HISTORIC AND DESIGN REVIEW COMMISSION

June 05, 2019

HDRC CASE NO: 2019-169
ADDRESS: 314 E ROSEWOOD AVE
LEGAL DESCRIPTION: NCB 6728 BLK 4 LOT 35, 36 AND 37
ZONING: MF-33,H
CITY COUNCIL DIST.: 1
DISTRICT: Monte Vista Historic District
APPLICANT: Gordon Lee/Exxell Exxteriors
OWNER: Michael White
TYPE OF WORK: Construction of two, 1-story rear accessory structures
APPLICATION RECEIVED: May 17, 2019
60-DAY REVIEW: July 16, 2019
CASE MANAGER: Stephanie Phillips
REQUEST:

SHEET #
A-1
OF 2

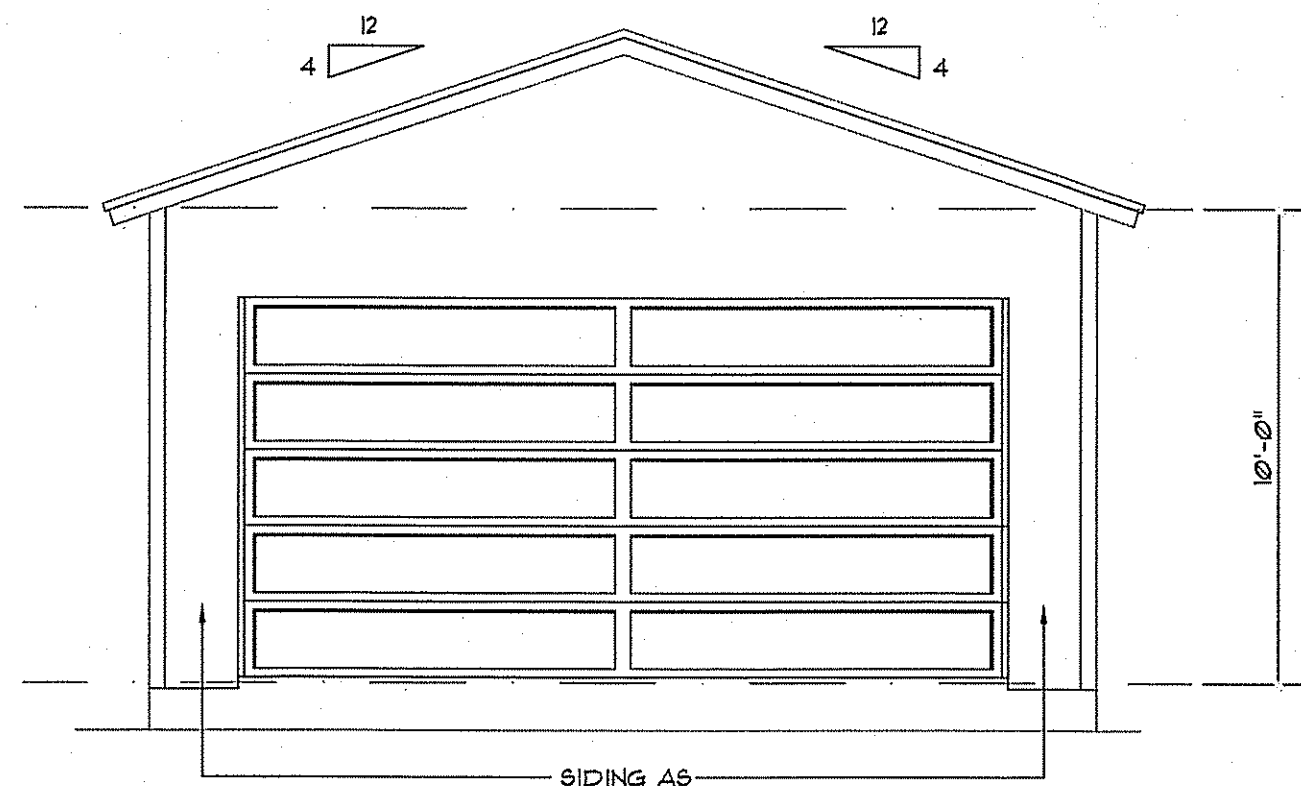
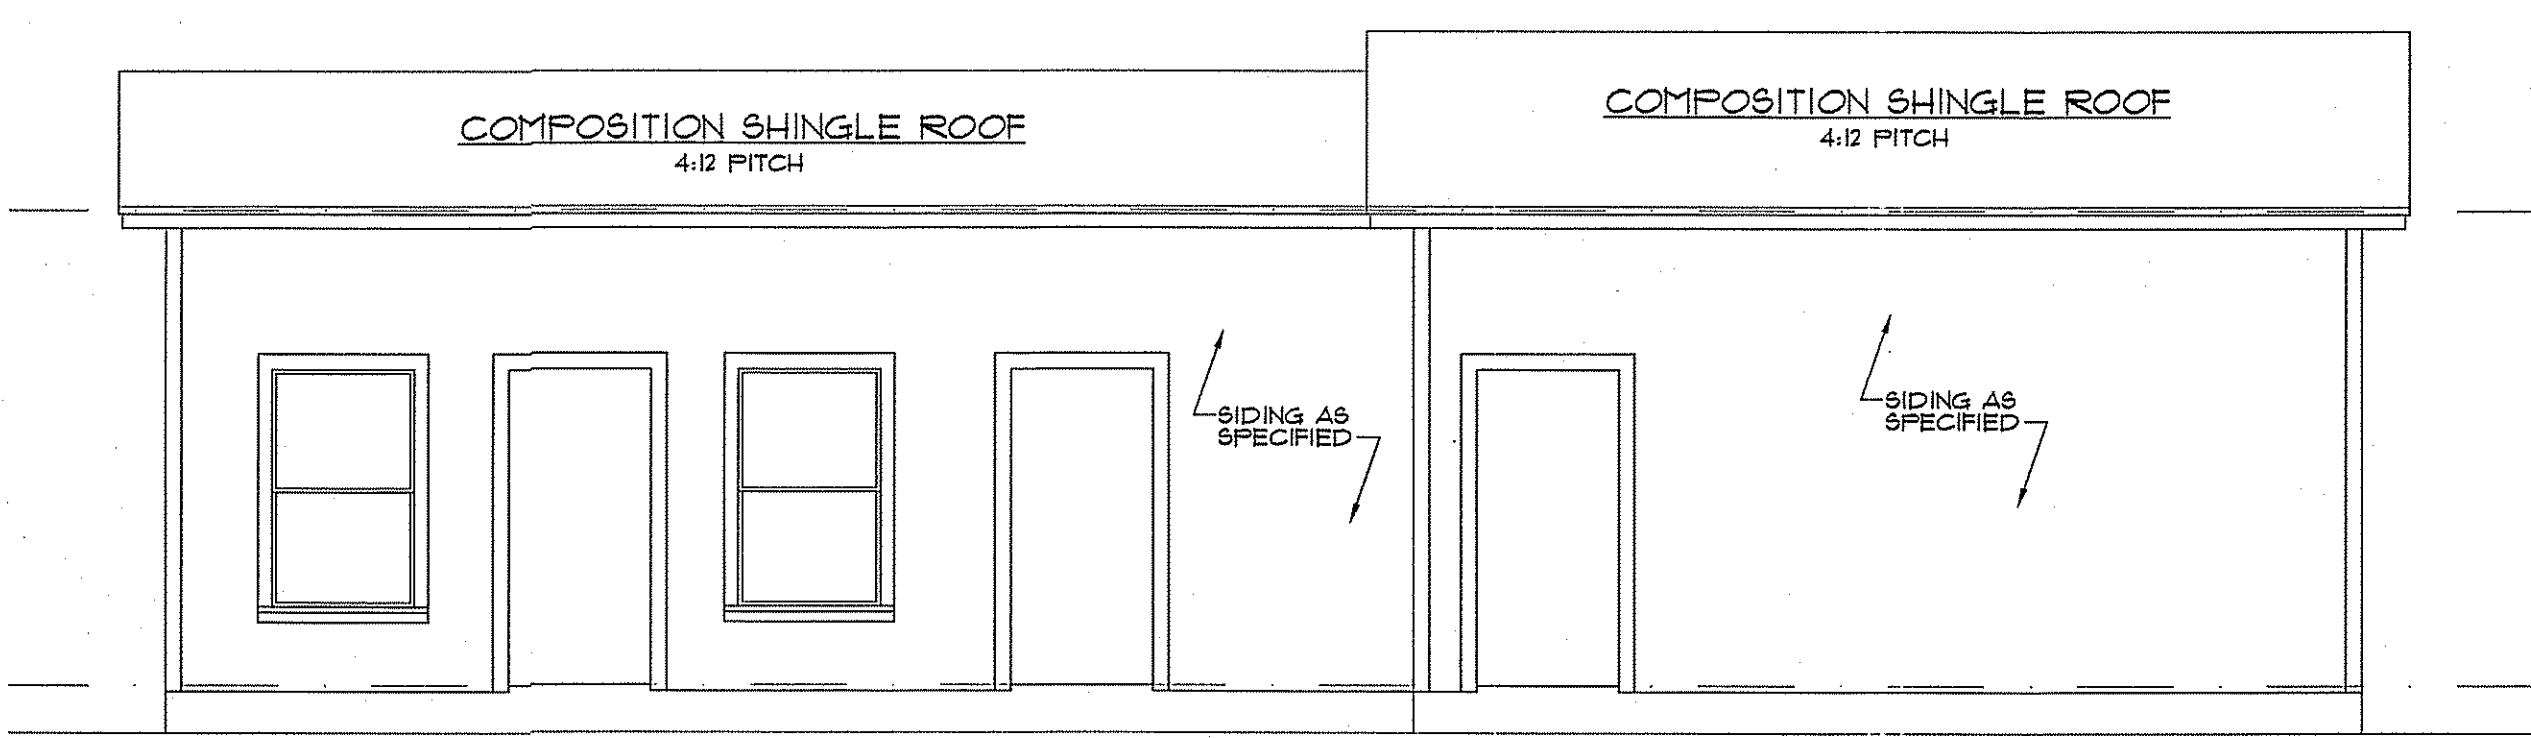
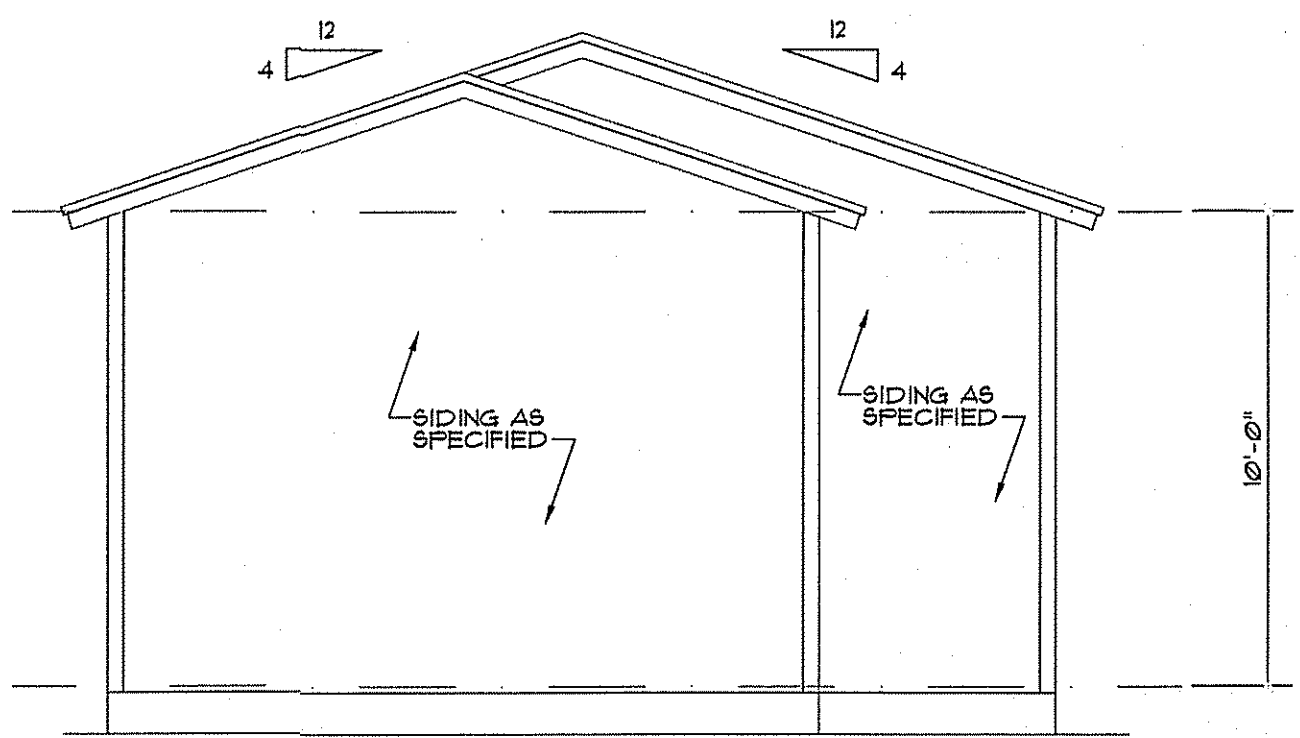
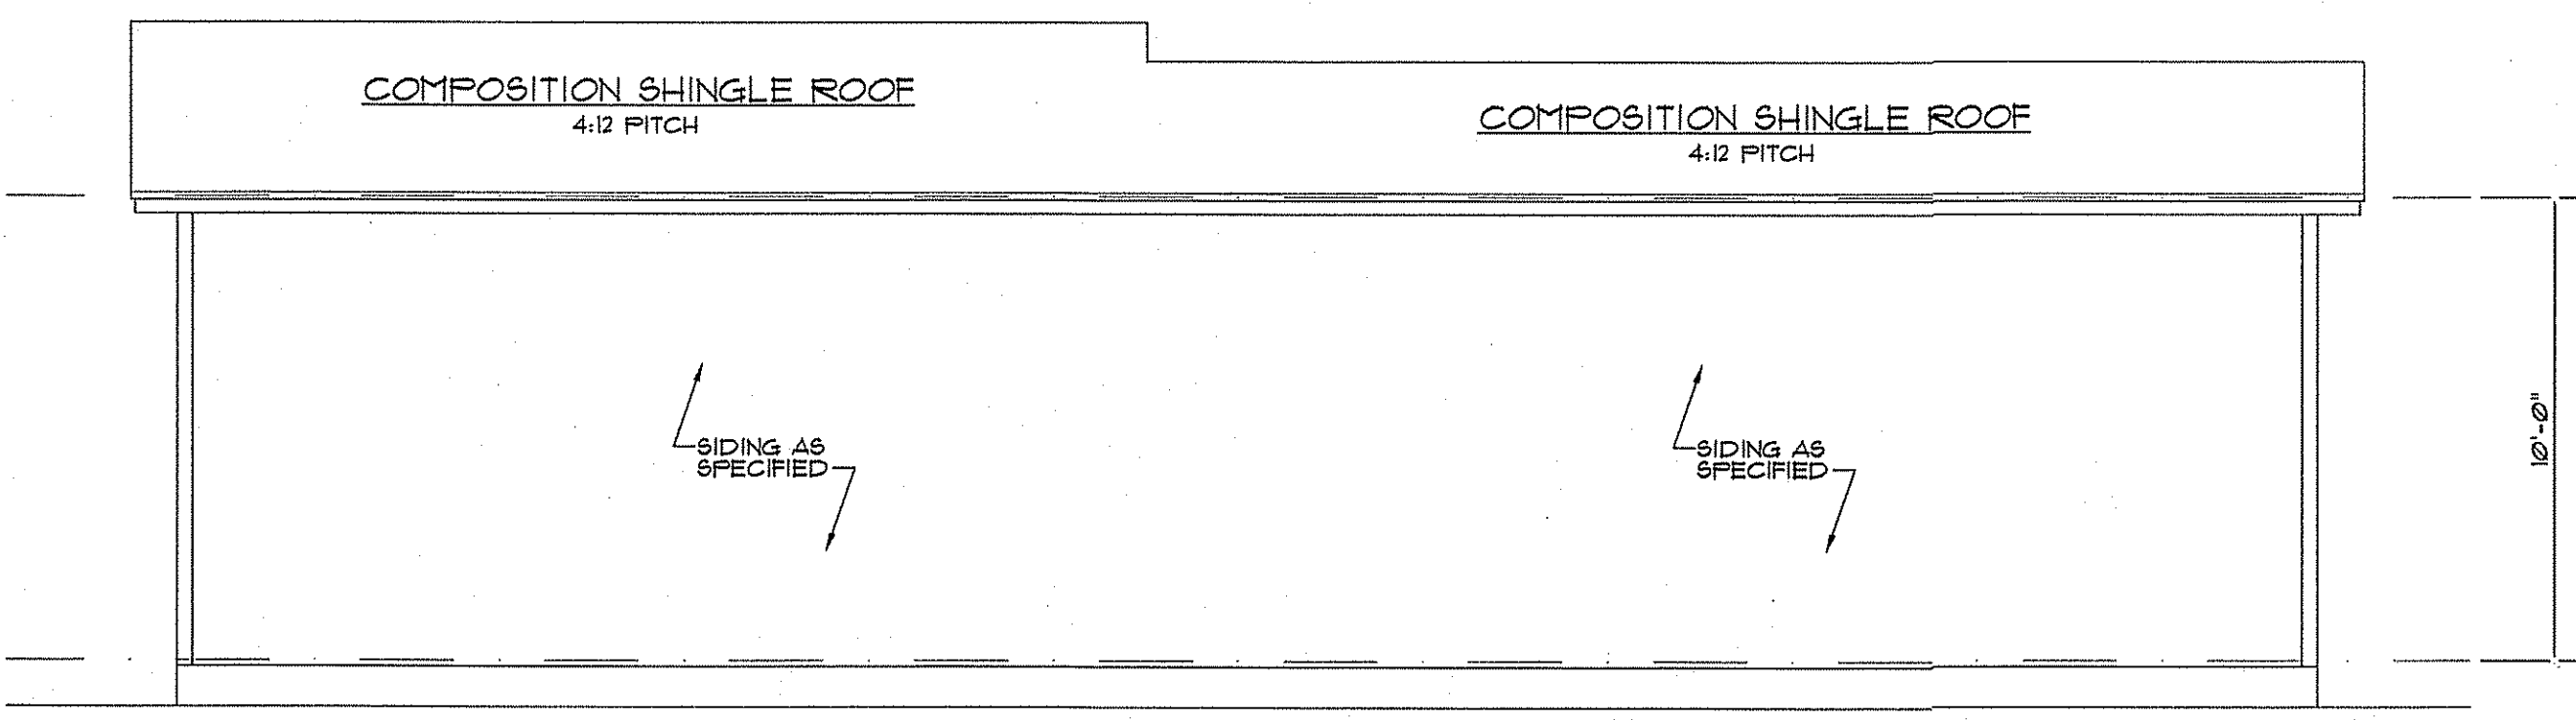
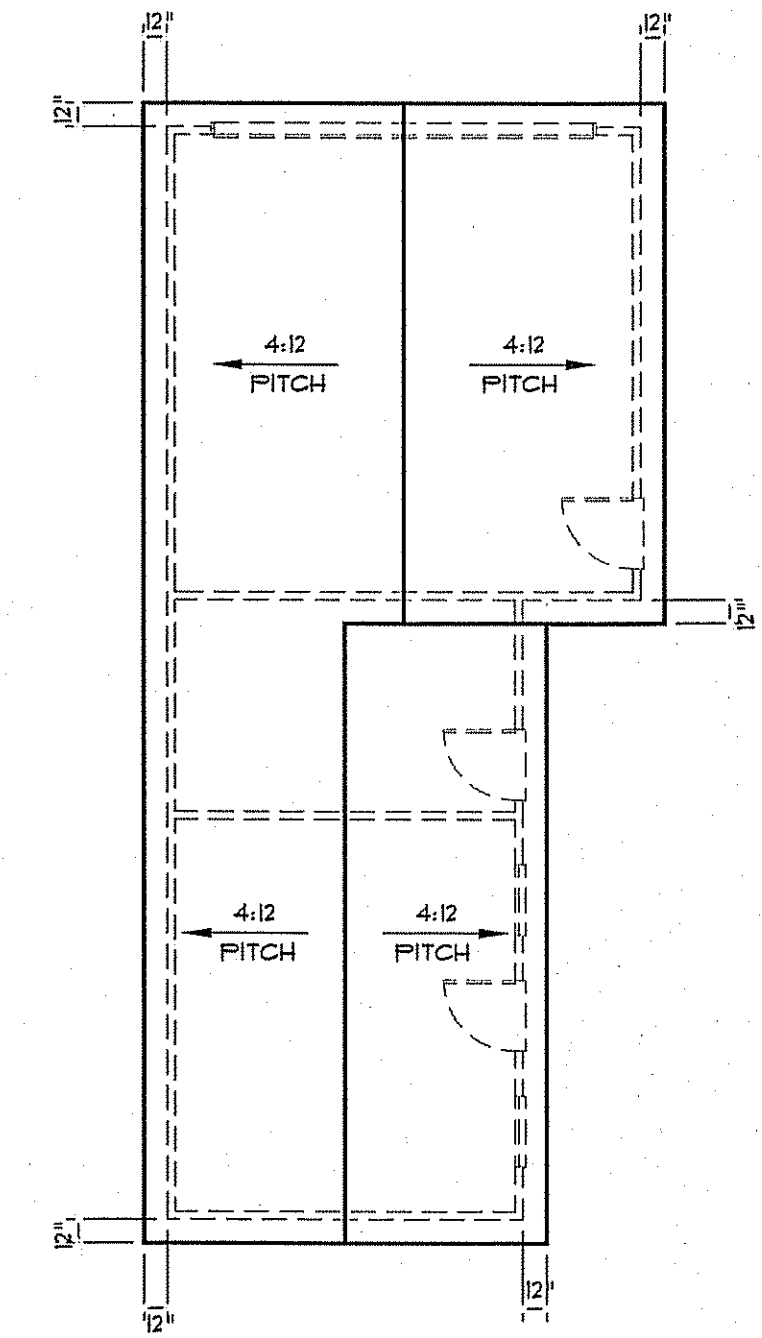
- e. GARAGE: SCALE & MASS – The applicant has proposed a 1-story garage structure with a gable roof. The structure will measure approximately fifteen feet in height. The Historic Design Guidelines state that new construction should be consistent with the height and overall scale of nearby historic buildings and rear accessory structures. The scale of the proposed structure does not impact or visually compete with primary structure on the lot or nearby historic structures, and will visually match the height of other garage structures along E Hollywood Ave. Staff finds the proposal consistent with the Guidelines.

- f. GARAGE: ROOF – The applicant has proposed a gable roof form for the structure. The roof will be constructed of shingles to closely match the materiality of the primary structure. Staff finds the proposal appropriate.

- g. GARAGE: MATERIALS –The Guidelines for New Construction state that materials should complement the type, color, and texture of those found in the historic district. The primary façade materials are not indicated in the application. The applicant has indicated that an existing non-original stone wall will be reused to frame the sides of the garage and that additional stone will be used to partially reconstruct the wall in a different location. Staff generally finds this approach consistent.

- h. GARAGE: FENESTRATION – The applicant has proposed several openings on the proposed garage structure, including an overhead garage door facing E Hollywood Ave and several openings on the west façade towards the interior of the lot. The openings appear to be generally proportionate and consistent with the Guidelines. While the long blank facade on the east (left) elevation is generally discouraged, staff finds that the proposed elevation's location immediately adjacent to a privacy fence presents a condition where a lack of fenestration will not detract from the surrounding conditions or the district. Staff finds the fenestration acceptable given these site-specific conditions.

- i. GARAGE: ARCHITECTURAL DETAILS – Generally, new buildings in historic districts should be designed to reflect their time while representing the historic context of the district. Architectural details should also not visually compete with the historic structure. While staff finds the roof form and general scale to be appropriate, staff finds that the structure should establish a stronger visual language with the primary historic structure and existing accessory structure on site through architectural details. Staff recommends that the applicant incorporate gable vergeboarding detail or similar elements pulled from the primary structure to strengthen this connection.

- i. That the applicant incorporates gable vergeboarding detail or similar architectural elements into the garage design as noted in finding i. The applicant is required to submit final elevations, plans, and design details to staff for review and approval prior to obtaining a Certificate of Appropriateness.

- ii. That the applicant provides final door and window specifications for final approval. The doors should be wood and the windows should meet the following stipulations: Meeting rails must be no taller than 1.25” and stiles no wider than 2.25”. There should be a minimum of two inches in depth between the front face of the window trim and the front face of the top window sash. This must be accomplished by recessing the window sufficiently within the opening or with the installation of additional window trim to add thickness. Window trim must feature traditional dimensions and architecturally appropriate sill detail. Window track components must be painted to match the window trim or concealed by a wood window screen set within the opening.
